# CITY OF ALBUQUERQUE

RE: Abrazo Homes  
**Lot 6 Block 8 Unit 18 SAD 228**  
**6505 Canavio NW**  
**Grading and Drainage Plan**  
**Engineers Stamp Date 10/19/16 (D10D003O6)**

Based upon the information provided in your submittal received 9/8/16, this plan is approved for Grading Permit and Building Permit.

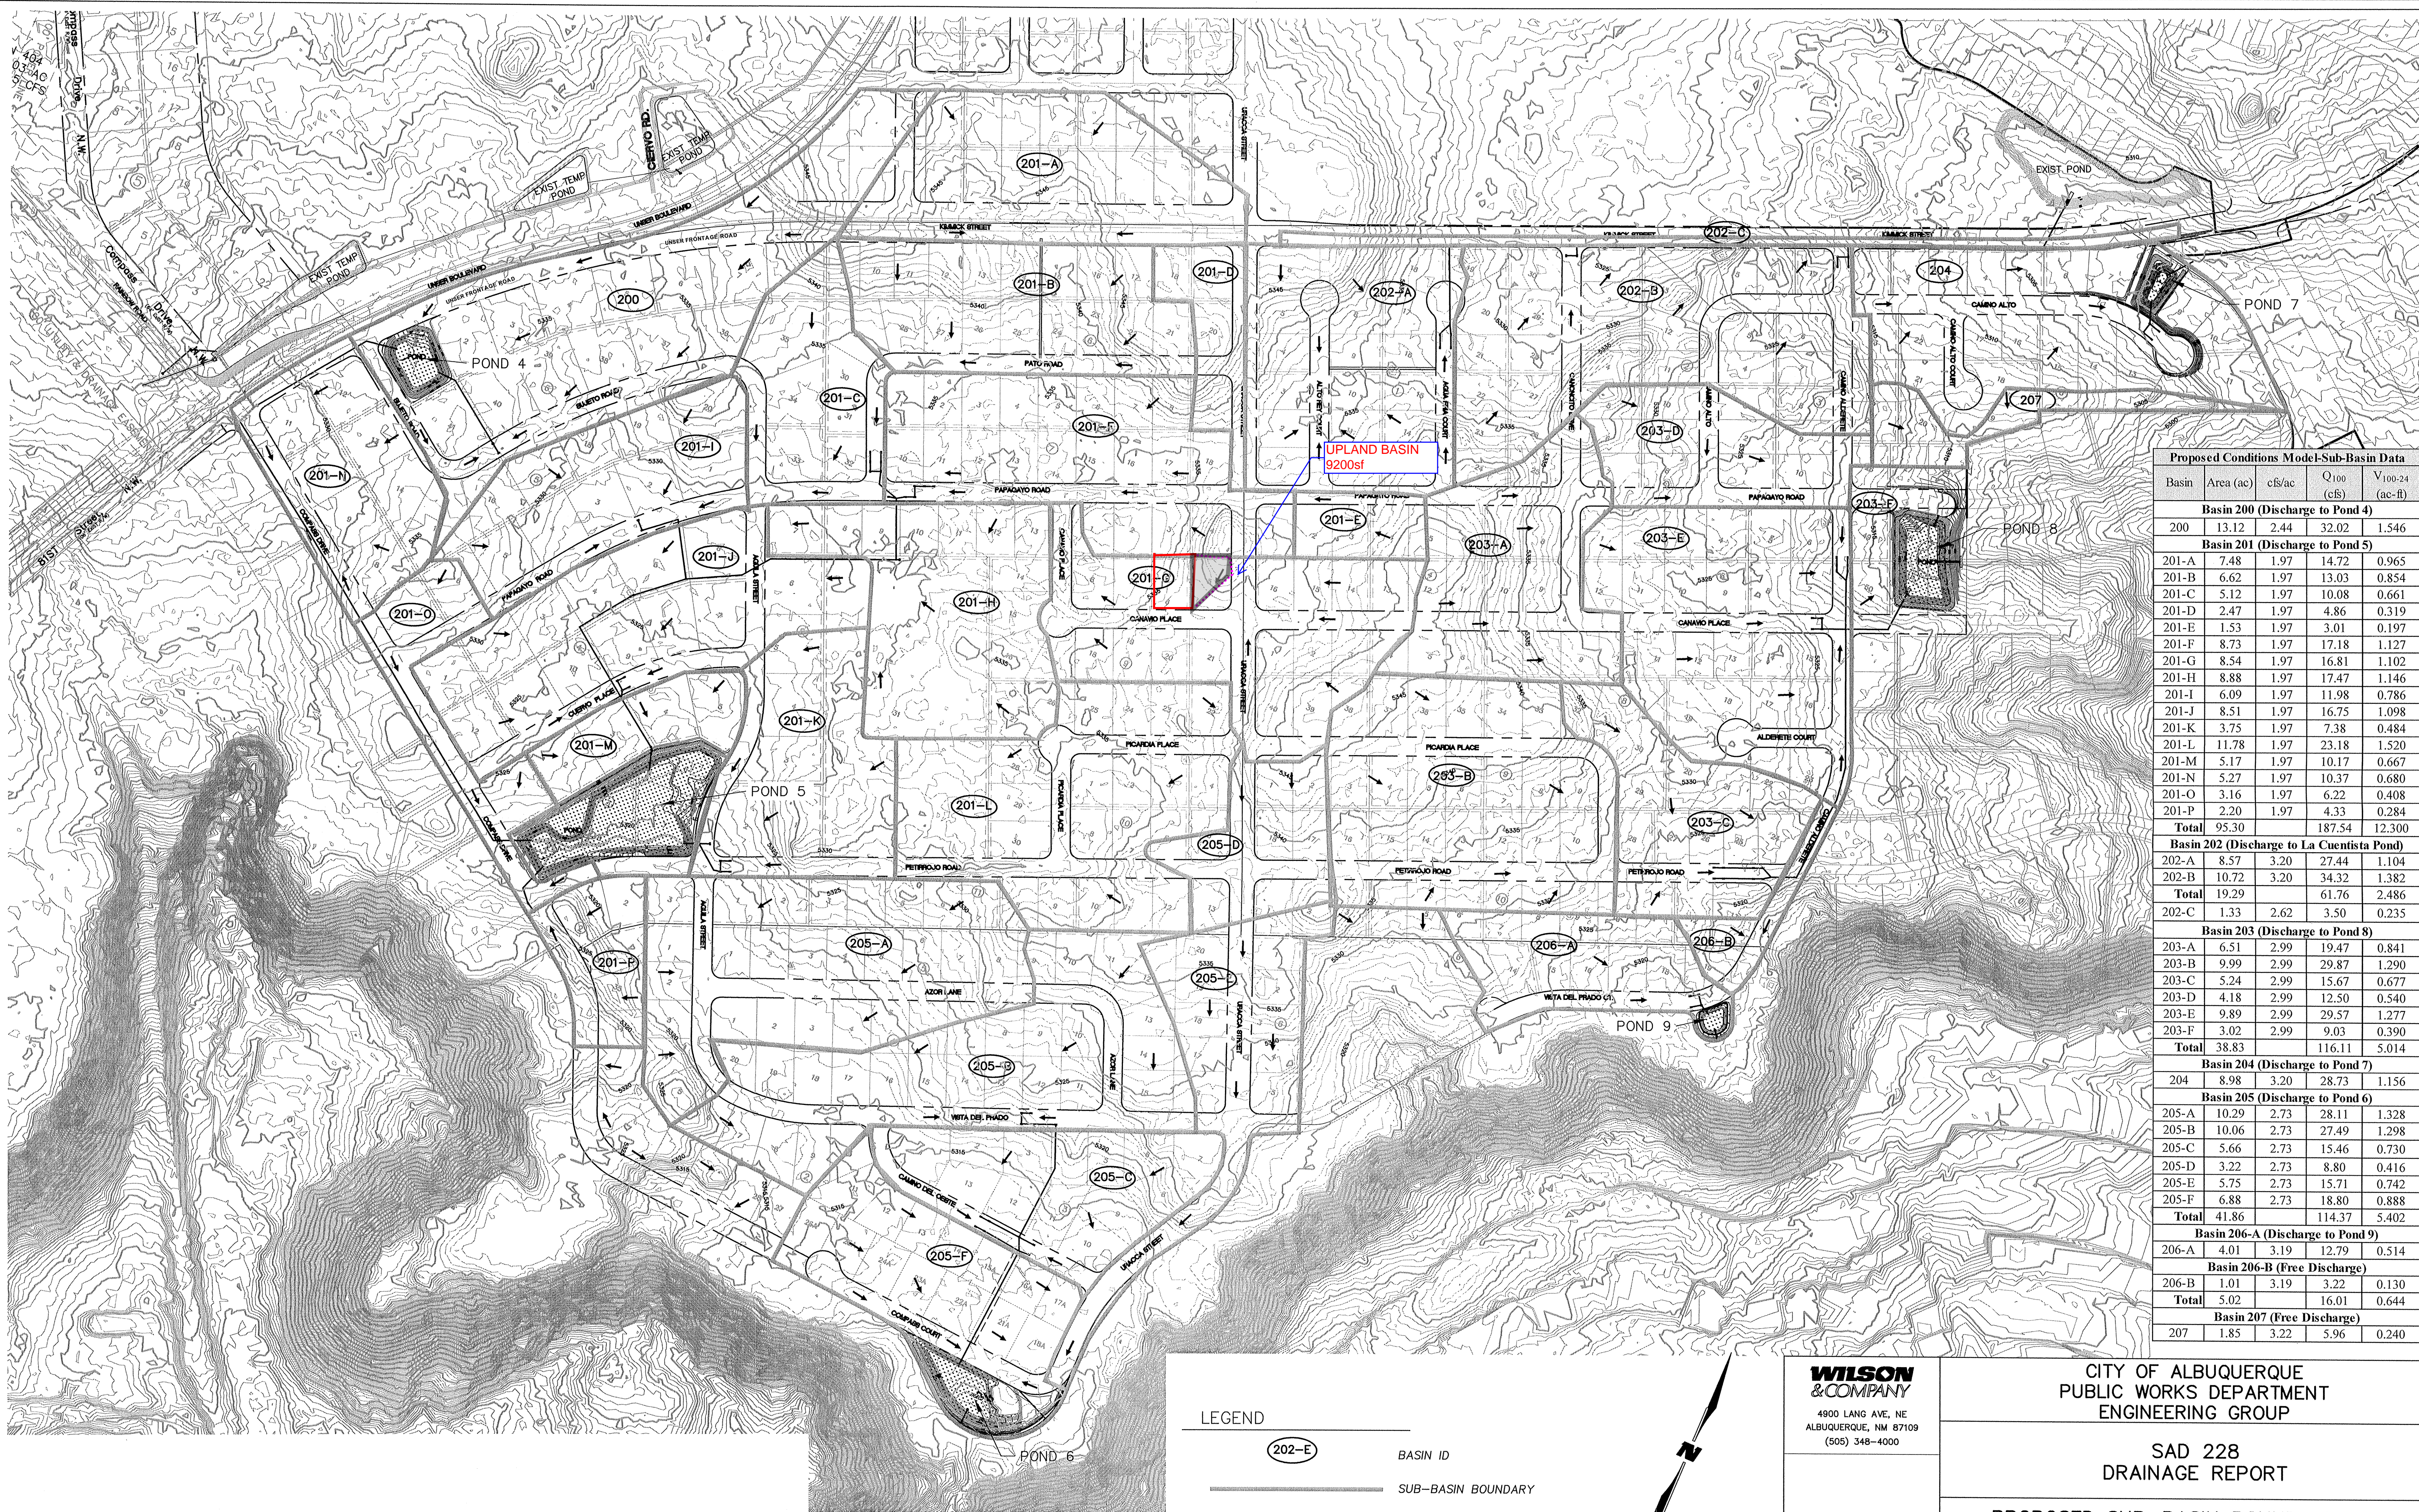
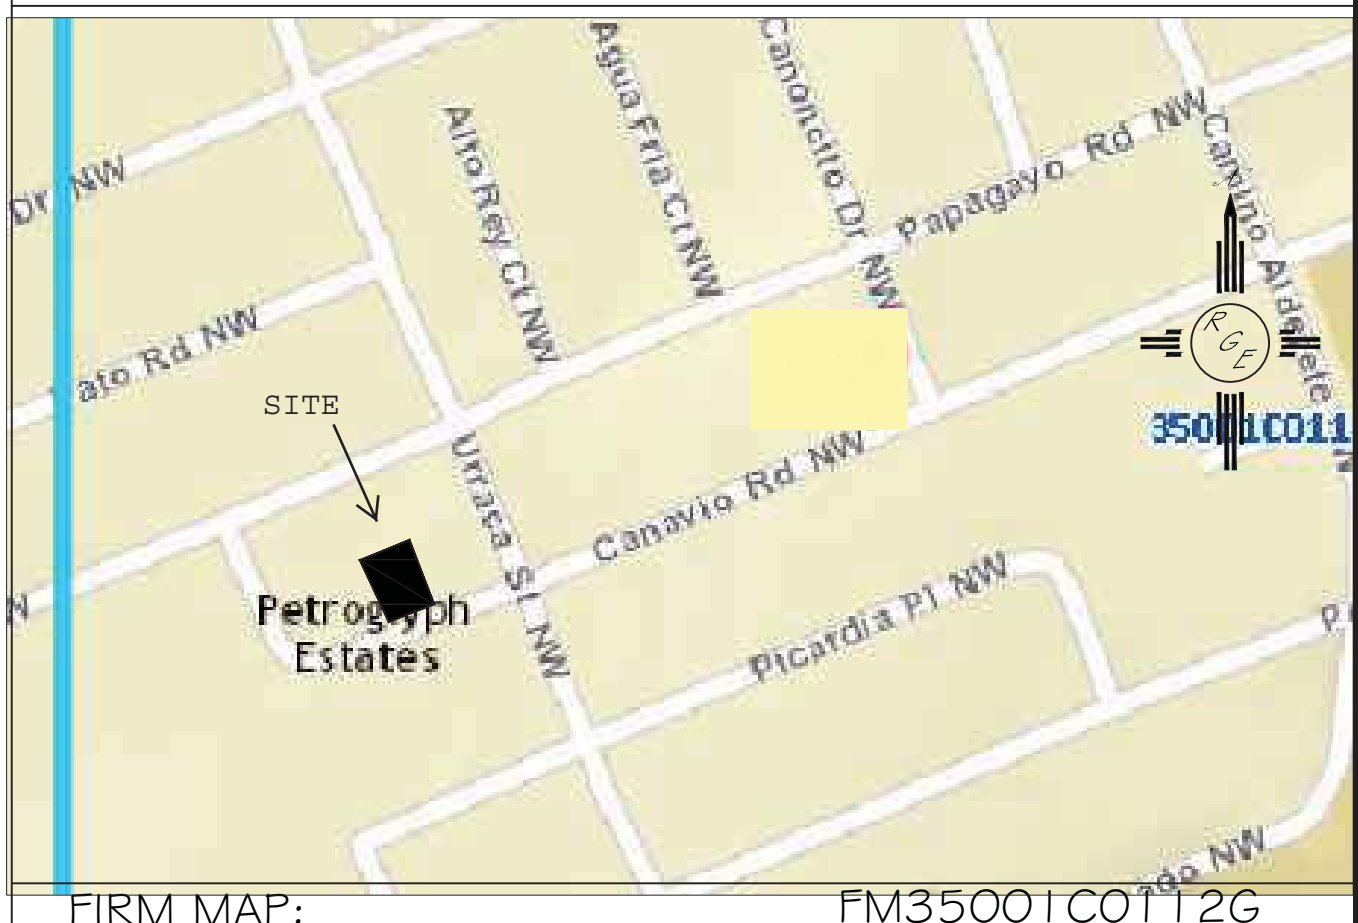
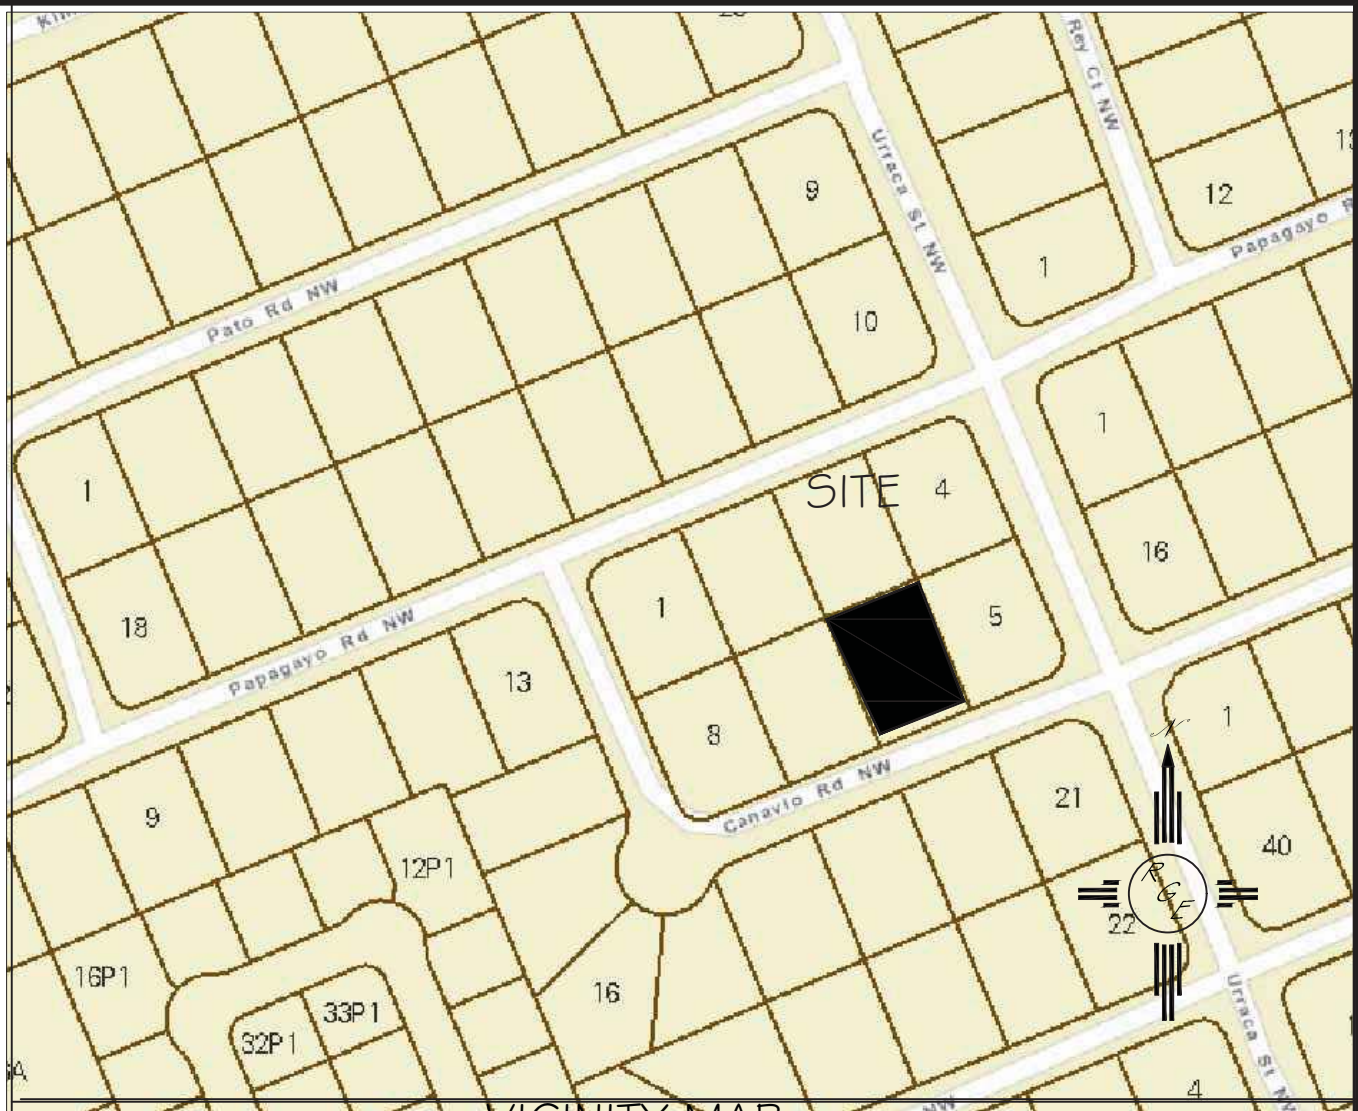
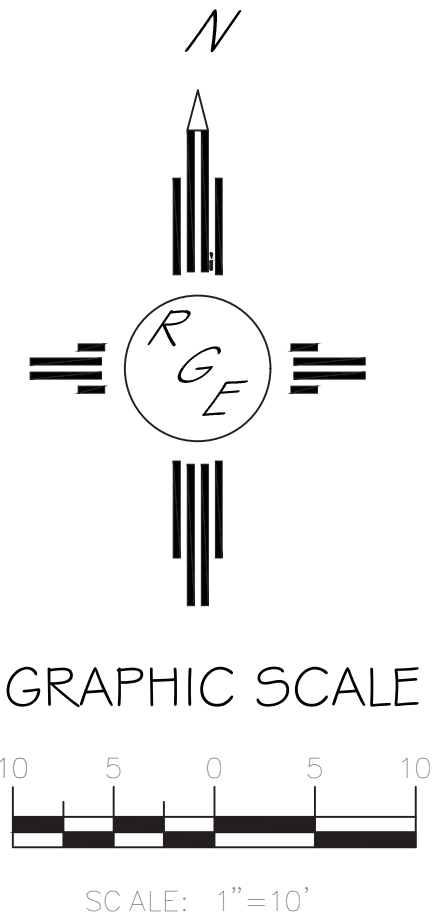
Please inform the builder to attach a copy of this approved plan to the construction sets in the permitting process prior to sign-off by Hydrology. Also, notify the owner/contractor that a separate permit for the fence is required.

Prior to construction of the home, a pad certification will be required. A hold on the property will be placed until this certification has been approved.

Prior to Certificate of Occupancy release, Engineer Certification per the DPM checklist of this plan will be required.
